Application for Consideration of a Subdivision and/or Land Development Plan

PROJECT NO.: 4939-50	DATE: APRIL 1, 2024	DRAWN BY: BRC	CHECKED BY: BRC
SCALE: 1"=100' 			
PROPOSED SKETCH PLAN PROPOSED SITE PLAN FOR MOUNT JOY TOWN CENTER PENNMARK MANAGEMENT COMPANY MOUNT JOY TOWNSHIP LANCASTER COUNTY, PENNSYLVANIA

Justin Evans, AICP
Township Manager
Mount Joy Township
8853 Elizabethtown Road
Elizabethtown, PA 17022

Re: Penmark Management Company
Proposed Site Plan (Zoning Hearing Board application)
LCEC Project No: 25-127

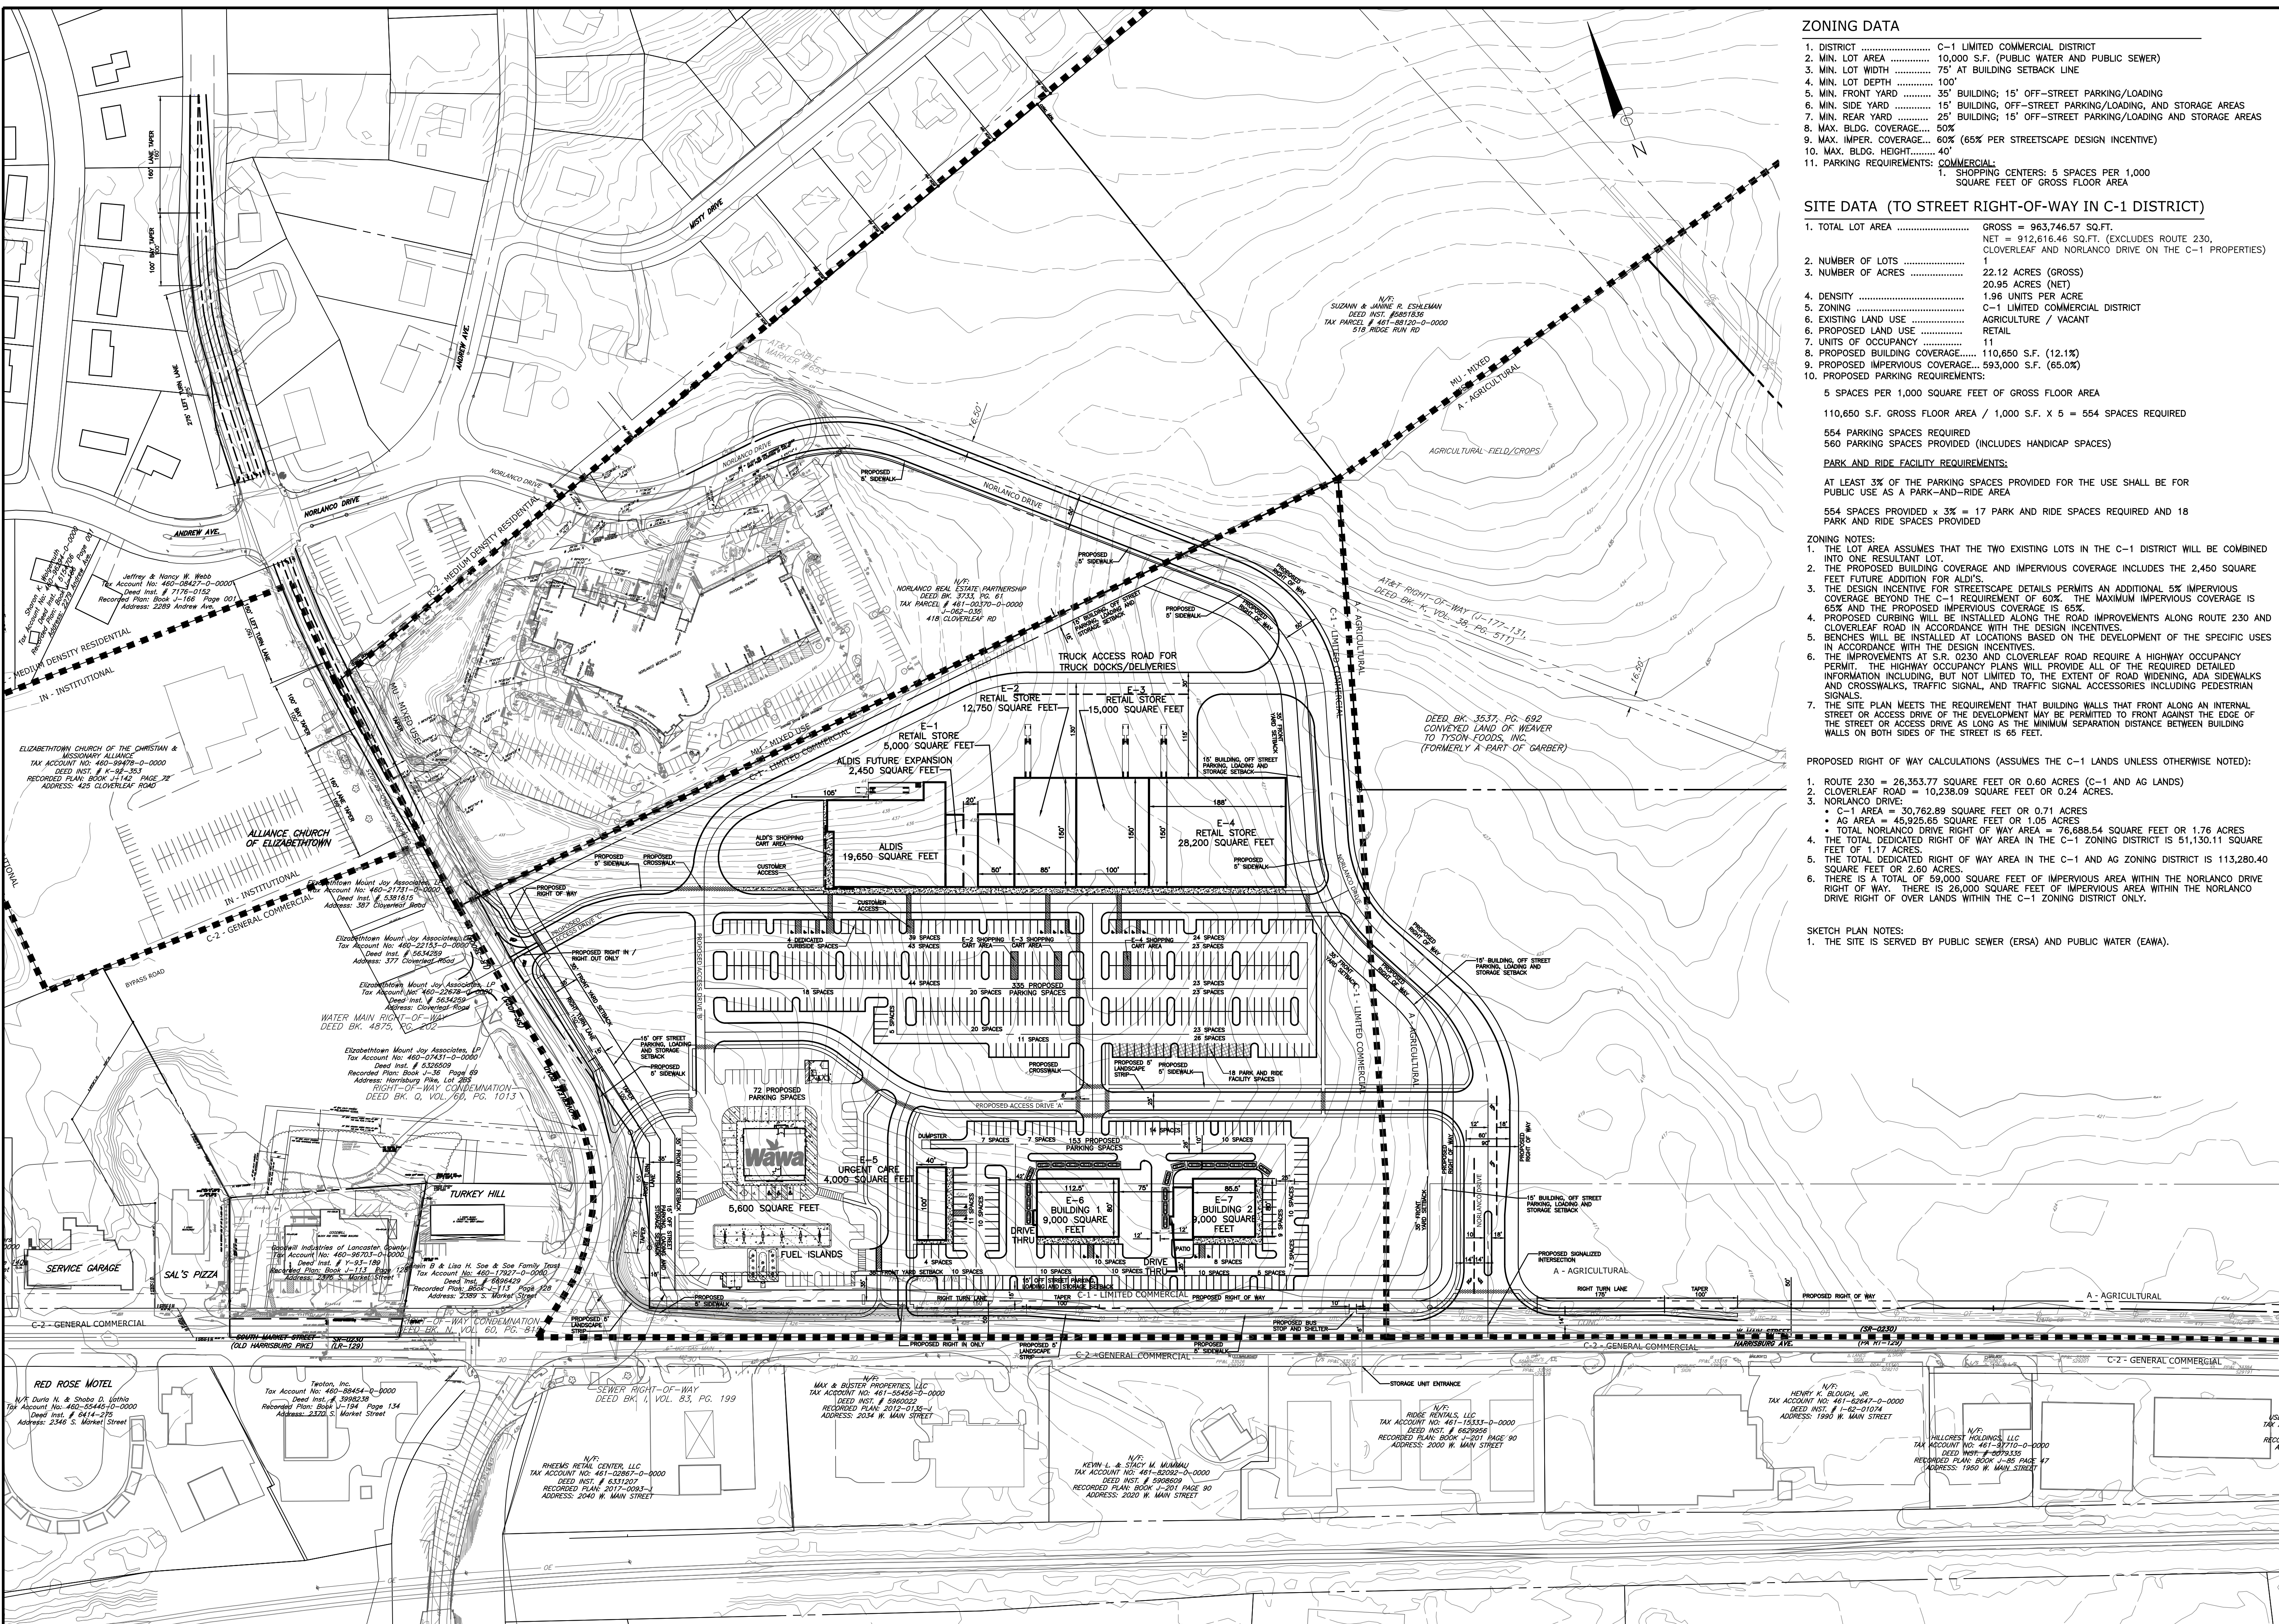
1. The proposed shopping center use is not a permitted use in the Limited Commercial District (135-122.C).
2. The proposed vehicular fuel pump use is not a permitted use in the Limited Commercial District (135-122.C & 135-256.A(3)).

3. A retail store in excess of 10,000 square feet of floor area is a Special Exception use in the Limited Commercial District (135-123.B).
4. Vehicle stacking lanes shall be separated from other vehicle circulation lanes and parking areas (135-255.C). The proposed drive-throughs shall meet this requirement.

5. The proposed floor area of a retail store in the Limited Commercial District shall not exceed 50,000 square feet of gross floor area (135-256.A(1)). The gross area of the proposed retail stores does not meet this requirement.

6. The proposed bus stop location shall be reviewed and acceptable to the Red Rose Transit Authority (135-256.C(3)). The Authority has provided a letter dated February 24, 2023 confirming the feasibility of a bus stop at this site, but further coordination is needed during the land development process.

7. The proposed shopping center shall provide safe and convenient pedestrian linkages to the nearby commercial developments (i.e. Turkey Hill and Rheems Retail Center) (135-256.C(5)).

8. The applicant shall demonstrate that the proposed nonresidential use is compliant with the access management requirements found in Section 135-326.A(1) or (2) which requires access from a side street (for a corner lot) or only one shared access drive onto arterial roads.

9. The final subdivision and land development design for the proposed development shall meet all streetscape detail requirements for retail stores and shopping centers in excess of 10,000 square feet of gross floor area (135-256.E(6)).

10. A minimum of a five-foot-wide planting strip shall be provided between the back of the curb and the edge of the sidewalk along the street right-of-way (135- 256.E(6)(b)).

11. A cross access easement agreement shall be executed for the shared access drive (135-294.A).
12. An exterior lighting plan shall be submitted (135-298.D).

13. All nonresidential uses shall contain a landscape screen when such use is adjacent to a property that is available for residential use (i.e. the Ag district) (135-299.C(1)).

14. A cross access easement and maintenance agreement in a form acceptable to the Township Solicitor shall be executed and recorded (135-321.C & 135-344.C).

15. Off street loading space information shall be shown on the plans (135-346).
16. Evidence shall be provided that the proposed loading areas for deliveries and for trash pickup on are adequate in size and can be used without blocking or interfering with internal circulation (135-346.A).

17. A landscape screen shall be provided for off-street loading facilities adjoining public street rights-of-way (135-346.C). A landscape screen shall be provided between the loading docks for the retail stores E-2 through E-4 and Norlanco Drive.

18. Distances and bearings for the entire site boundary shall be shown on the plan (119-31.A(2)). Tracts 1 and 2 of the Elizabethtown Mount Joy Associates, L.P. property shall meet this requirement.

19. The plans shall be presented in a clear, legible, coherent and organized manner. Due to the scale of the plans, some of the text and markings are unclear, especially labels of existing features on adjacent properties. It is recommended that a linetype and symbol legend be added to the plans (119-31.A(4)).

20. The plans shall be signed and sealed by a registered engineer, surveyor or landscape architect (119-31.A(5)).
21. Norlanco Drive is proposed on Tracts 1 and 2 of the Elizabethtown Mount Joy Associates, L.P. property; therefore, these properties shall be listed as subject tracts (119-31.B(3)).

22. The applicant shall confirm whether there will be grading on the adjacent Tyson Foods, Inc. property. If grading will occur on the Tyson Foods, Inc. property, it shall be listed as a subject tract. Alternatively, an easement could be provided for the proposed grading (119-31.B(3)).

23. A location map shall be shown on the plan (119-31.B(8)).
24. The tax parcel identification number shown in the "Owners: Tract 1 and Tract 2" title block shall be corrected (119-31.B(10)).

25. The plan shall identify all prior plans, including all notes or restrictions affecting the current development, with a verification signed by the design professional that such list is complete and correct (119-31.B(14)).

26. The dimensions of the proposed right-of-way and cartway for Cloverleaf Road shall be shown on the plans (119-31.B(18)).
27. The dimensions of the existing rights-of-way and cartways for the existing streets shall be shown on the plans (119-33.C(2)(a)).

28. The location of the existing stormwater facilities, as well as the easements for the on-lot septic on Tract 1 of the Elizabethtown Mount Joy Associates, L.P. property, shall be shown on the plans (119-33.C(2)(a)).

29. The right-of-way of the existing water main along Cloverleaf Road (S.R. 4025) shall be dimensioned (119-33.C(2)(a)).
30. The existing access drives within 200 feet of the subject tracts shall be dimensioned. The rights-of-way and cartways for the existing streets within 200 feet of the subject tracts shall be dimensioned (119-33.C(3)(a)).

31. The zoning requirements, as well as the proposed conditions, shall be added to the Zoning Data table for the Agricultural District for Tracts 1 and 2 of the Elizabethtown Mount Joy Associates, L.P. property. The proposed conditions shall be added to the Zoning Data table for the Limited Commercial District for the Elizabethtown Associates property (119-33.D(2)).

32. The applicant shall confirm the units of occupancy shown in the Site Data table (119-33.D(4)). The table indicates that eleven (11) units are proposed; however, only nine (9) are shown on the plan.

33. The total number of lots (existing and proposed) and the density shown in the Site Data table on the Cover Sheet shall be corrected (119-33.D(4)). Tracts 1 and 2 of the Elizabethtown Mount Joy Associates, L.P. property shall be added to the Site Data table.

34. The proposed cartway widths near the cartway tapers on Cloverleaf Road shall be shown on the plans (119-33.D(5)).
35. The length of the taper on Cloverleaf Road near proposed Access Drive 'C' shall be shown on the plans (119-33.D(5)).

36. Building setback lines shall be shown on the plans for Tracts 1 and 2. The side and rear yard building setback lines shall be shown for the tracts of land between the western proposed right-of-way line of Norlanco Drive and the eastern property line of the Elizabethtown Associates property (119-33.D(7)).

37. The location of any recreation or open space land to be provided shall be shown on the plan (119-33.D(11)). The plans should also indicate whether the developer intends to dedicate required recreation and open space land or pay a fee in lieu of dedication.

38. The Official Map shows a proposed trail to be located along West Main Street (SR 320). The location of the proposed trail shall be shown on the plans (119-33.D(12)).

39. Evidence shall be provided with the land development submission to confirm that sufficient taper lengths for West Main Street and Cloverleaf Road have been provided (119-51.A(2)).

40. Building setback lines be shown for the Tyson Foods, Inc. property on the east side of the proposed Norlanco Drive (119-52.I(2)).
41. The frontage along West Main Street (SR 230), Cloverleaf Road (SR 4025), and Ridge Run Road shall be improved in accordance with 119-52.J or as indicated on the Township Official Map, whichever is greater. The required right-of-way indicated on the Official Map is 120 feet for West Main Street at the Cloverleaf/Colebrook Road and West Main Street intersection, 100 feet for Cloverleaf Road and West Main Street (along the lot frontage that is not for the aforementioned intersection improvements), and 60 feet for Ridge Run Road. Concrete curbing, concrete sidewalk, and pavement widening (if necessary) shall be provided along Ridge Run Road. Concrete curbing shall be provided along the entire frontage of West Main Street (SR 230). Improvements indicated on the Official Map include construction of a multi-use trail along West Main Street, a second through lane for West Main Street, a westbound left turn phase on West Main Street, and a second through lane for Cloverleaf Road (119-52.J(3)(a) & 119-53.B(2) / 119-53.C).

42. The developer shall take all necessary action to obtain PennDOT permits and/or approvals to install the necessary improvements to the state roadways (119-52.J(3)(e)).

43. Streetlighting shall be provided along new streets located within the designated growth area (119-52.O). Norlanco Drive shall meet this requirement.

44. No more than two access drives shall be located on a single street frontage (119-52.S(3)(g)). The access drives on Norlanco Drive shall meet this requirement.

45. The applicant shall address the traffic engineering comments provided by Traffic Planning and Design under separate cover (119-52.S(4)(c)).
46. Evidence shall be provided that the proposed loading areas for deliveries and for trash pickup on are adequate in size and can be used without blocking or interfering with internal circulation (119-52.S(6)).

47. Sidewalks shall be provided along both sides of Norlanco Drive for the entire length of the street (119-53.B(1)).
48. Sidewalks shall be provided along both sides of Access Drives A, B, and C for the entire length of the access drives (119-53.B(1)). The unlabeled access drives shall also meet this requirement.

49. Curbing shall be provided along both sides of Norlanco Drive (119-53.C(1)).
50. Street trees shall be provided along both sides of Norlanco Drive (119-59.G).
